HUDDERSFIELD

DESIGN & ACCESS STATEMENT ADDENDUM

SEPTEMBER 2024

Fig. 6.1.2 Proposed Amended Elevation - North Elevation

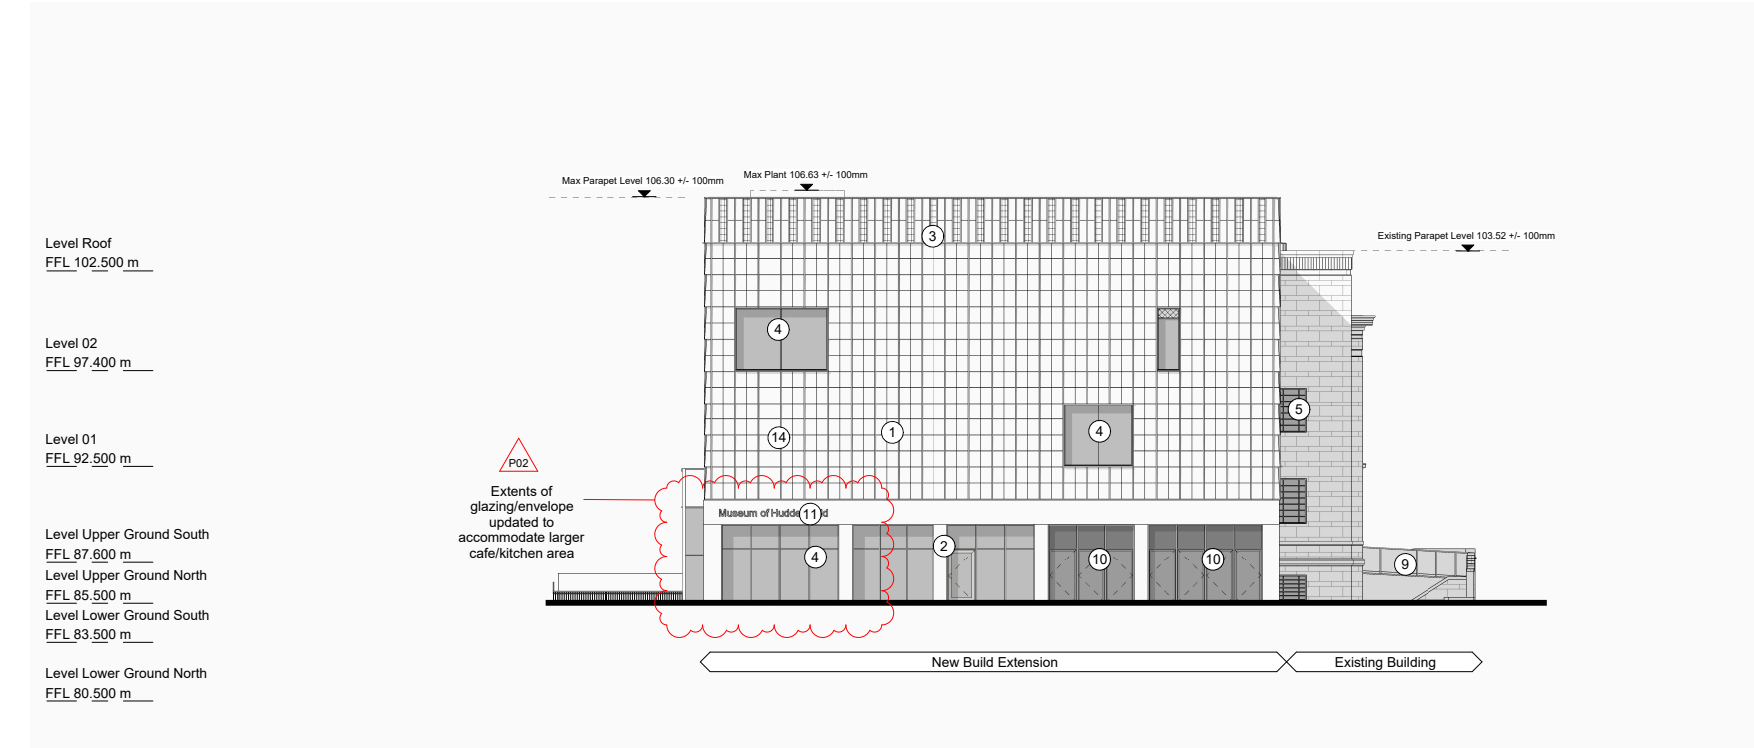
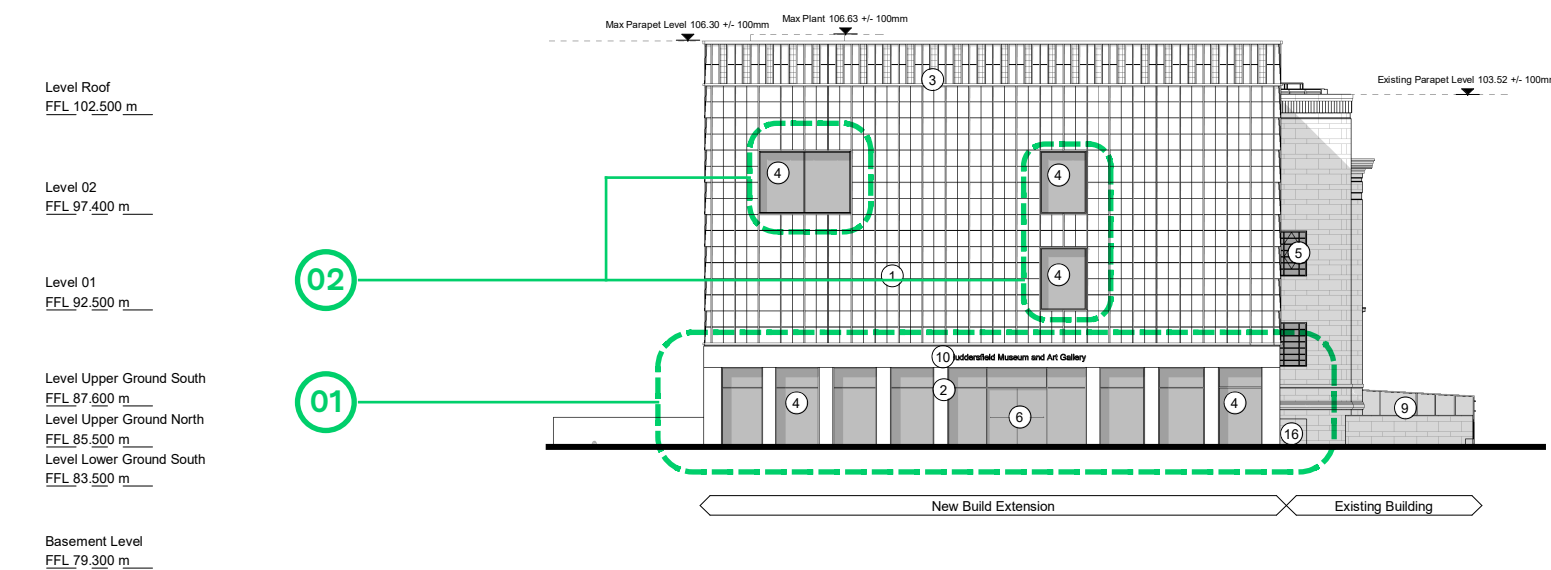
- 01 New entrance added to North facade providing better relationships to the proposed new park alongside the existing building. Facade piers updated inline with new entrance.
- 02 Window locations of North facade updated to align with internal layout changes and key views to surrounding context.

Fig. 6.1.4 Proposed Amended Elevation - East Elevation

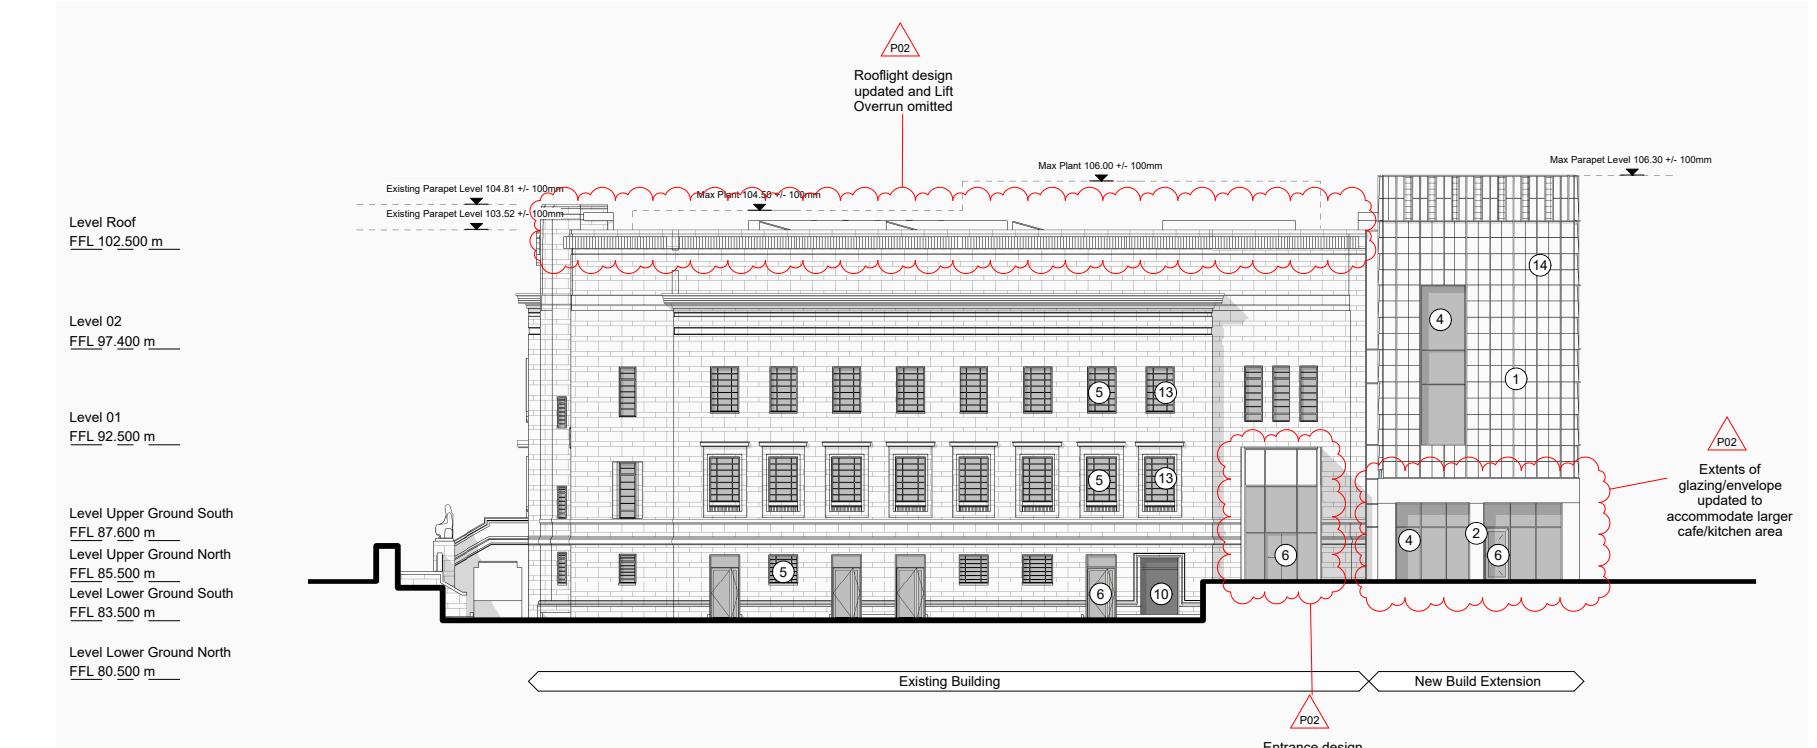
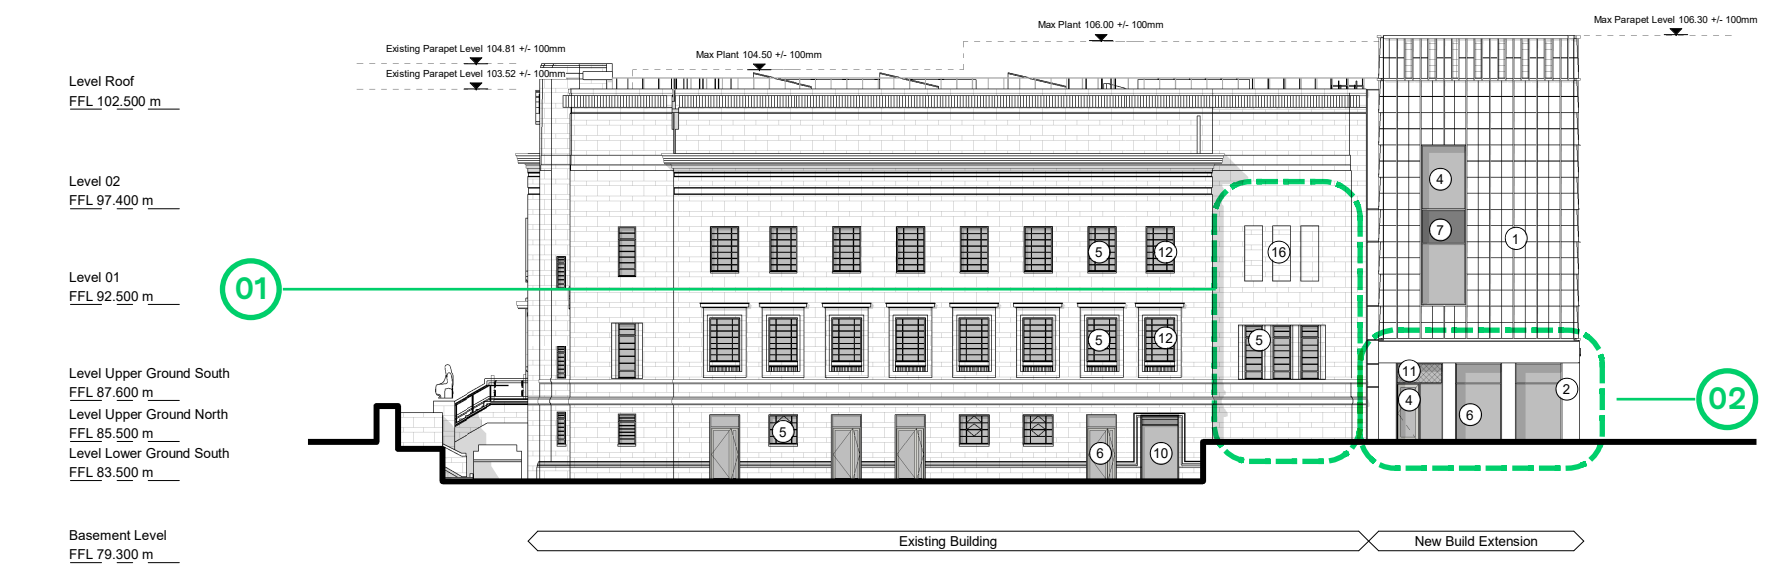
- 01 Entrance relocated to the North elevation. Existing windows on level 01 infilled to provide flexibility to Temporary Exhibition space.
- 02 Facade piers updated to emphasise new northern entrance.

Fig. 6.1.8 Proposed Amended Elevation - West Elevation

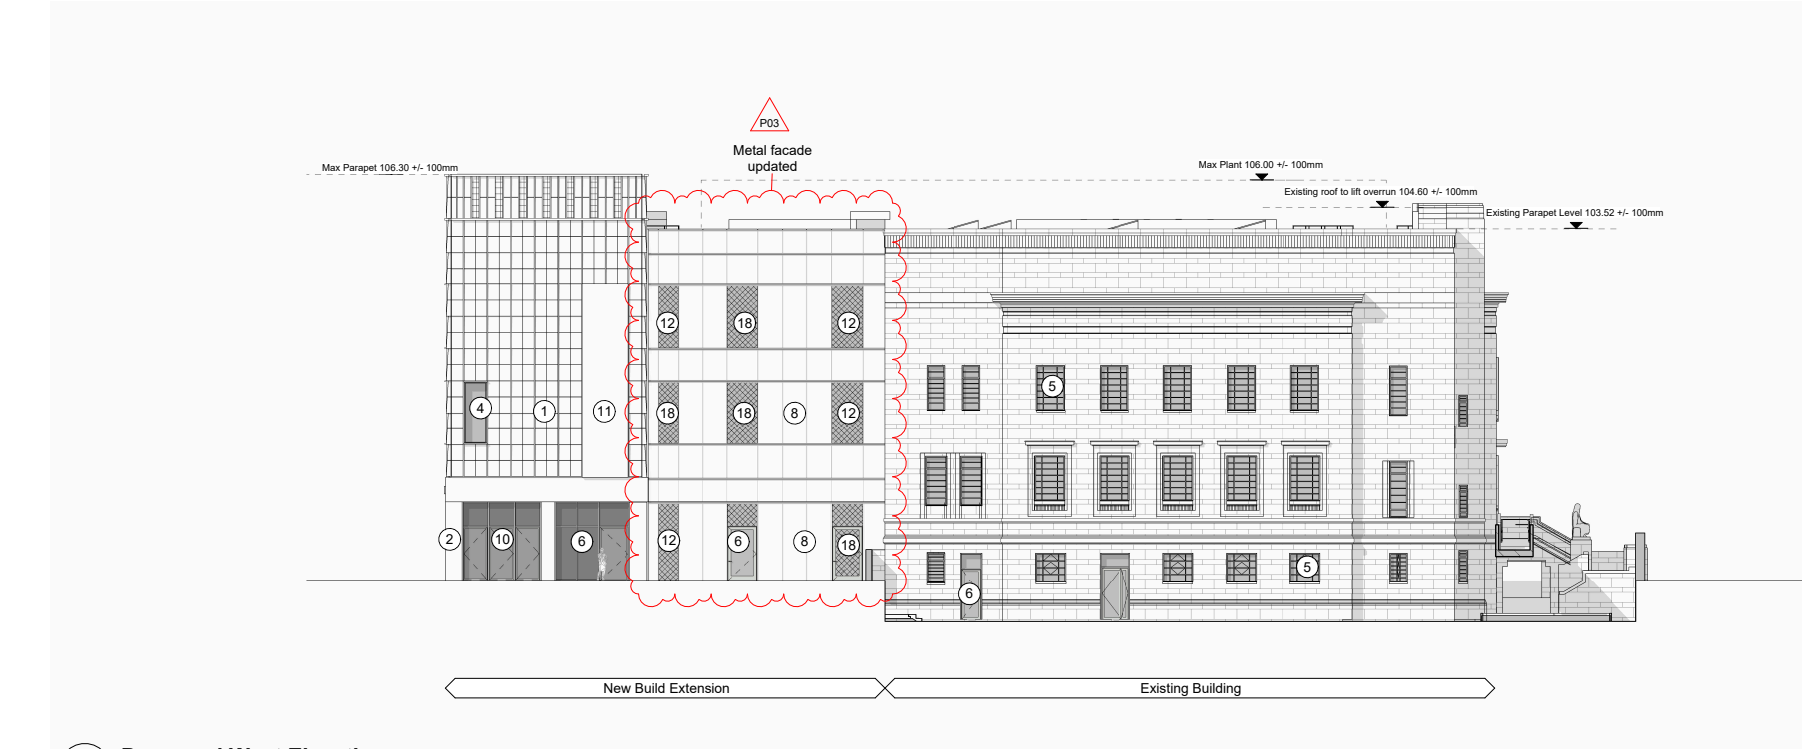
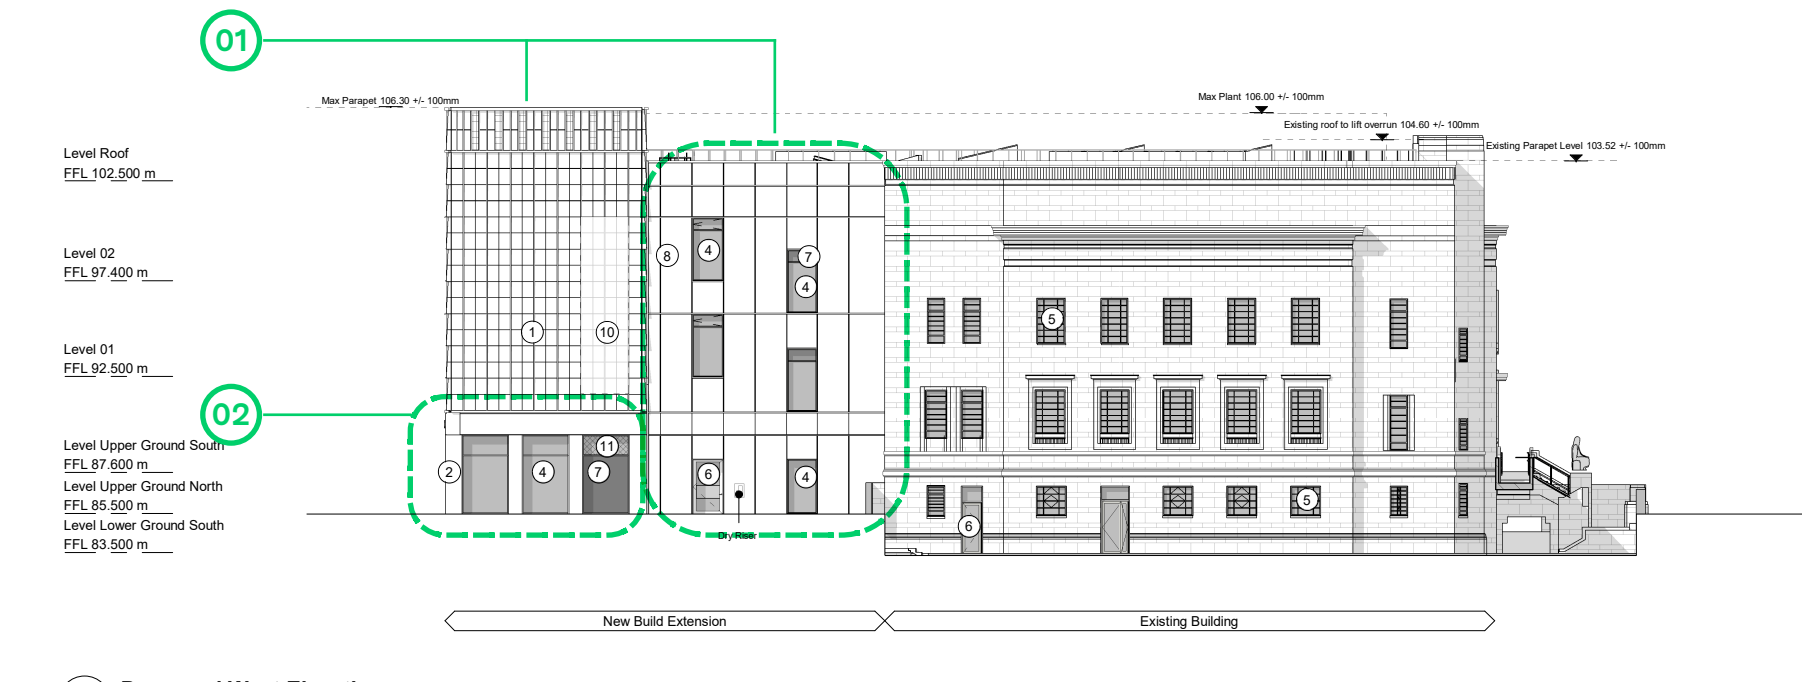
- 01 Window locations updated to suit internal updates and relocation of stair.
- 02 Facade piers updated to emphasise new northern entrance.

Fig. 6.3.8 Proposed Amended Section - Section 04

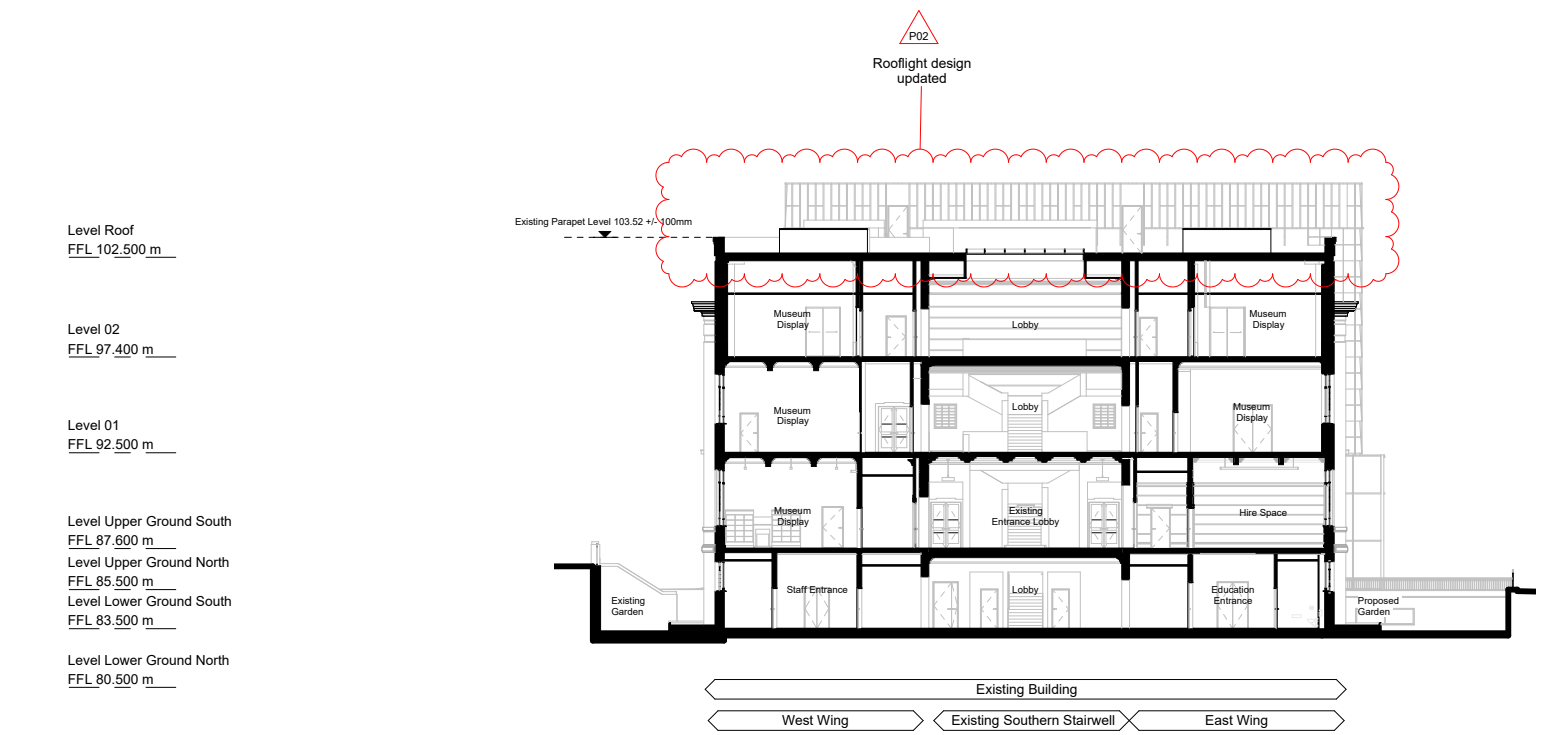
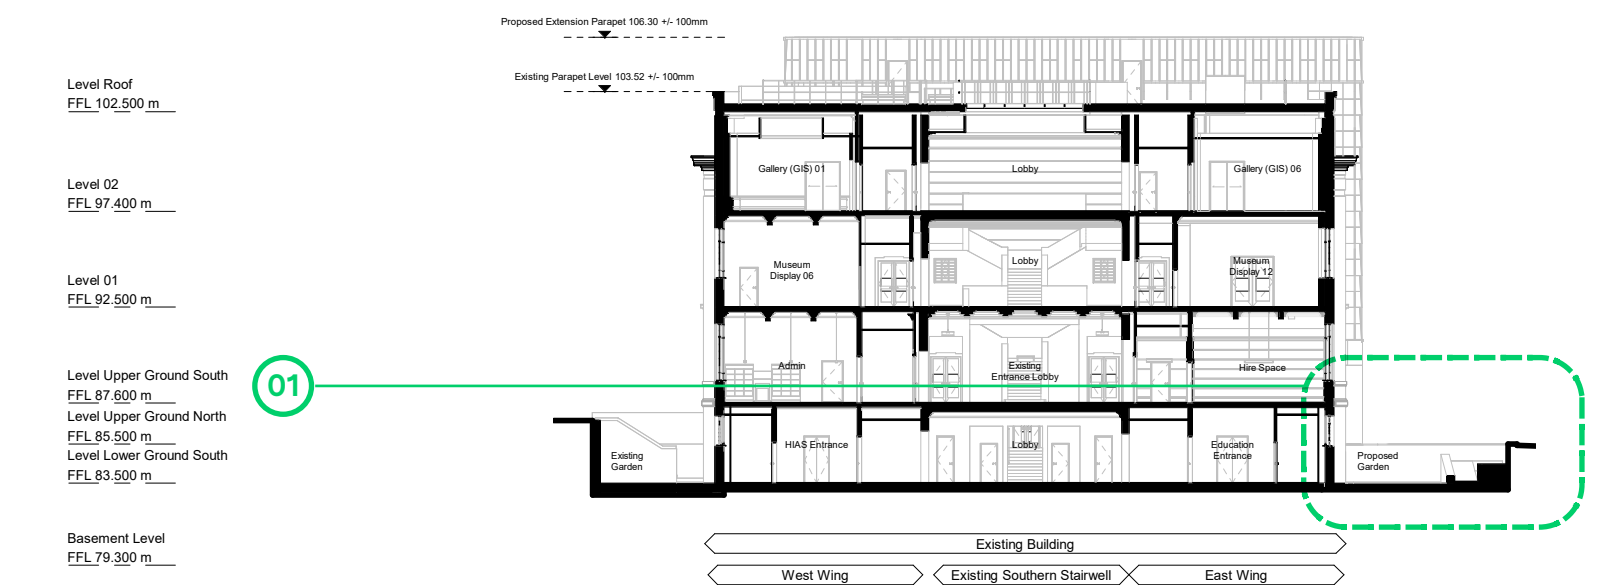
- 01 Eastern sunken terrace updated, refer to Public Realm section of report for details.

Fig. 6.3.6 Proposed Amended Section - Section 03

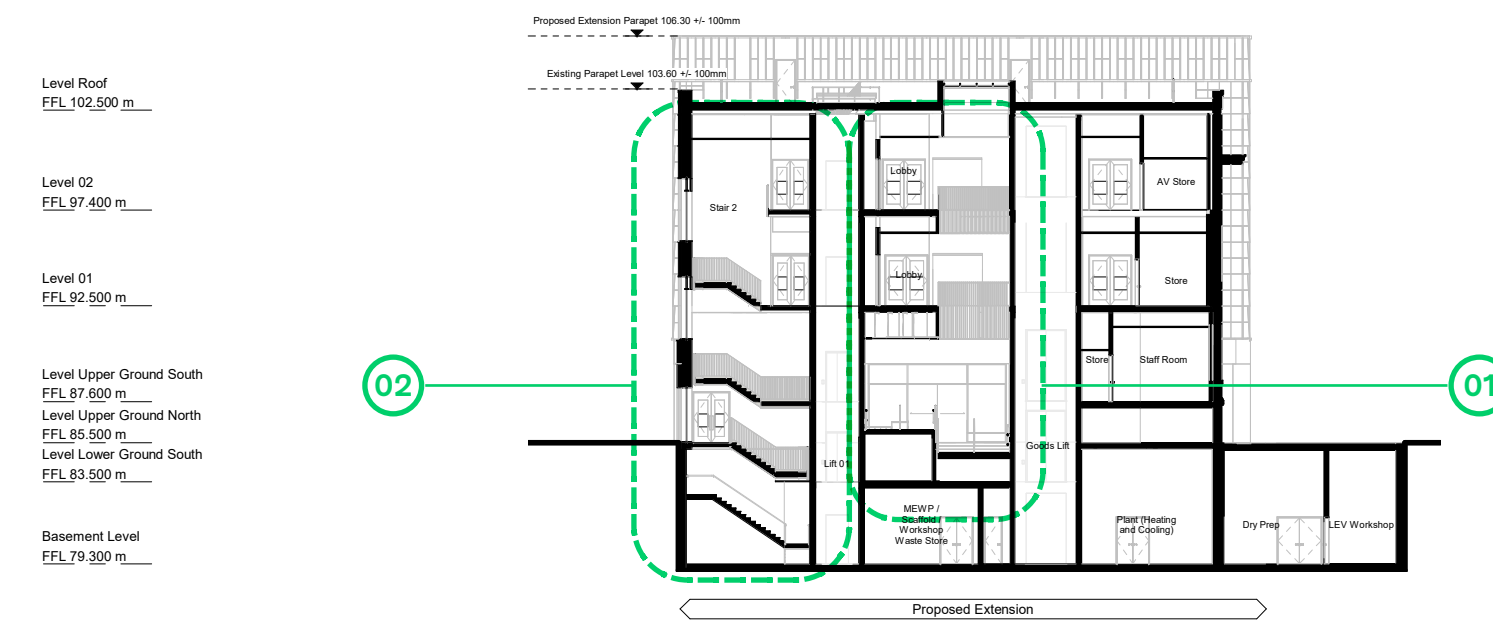
- 01 Feature stair omitted and new atrium design to provide addition area for museum and art gallery display whilst providing visibility and good user flow between floors. Roof light above amended to suit new design.
- 02 New stair added to the west providing access to all floors.
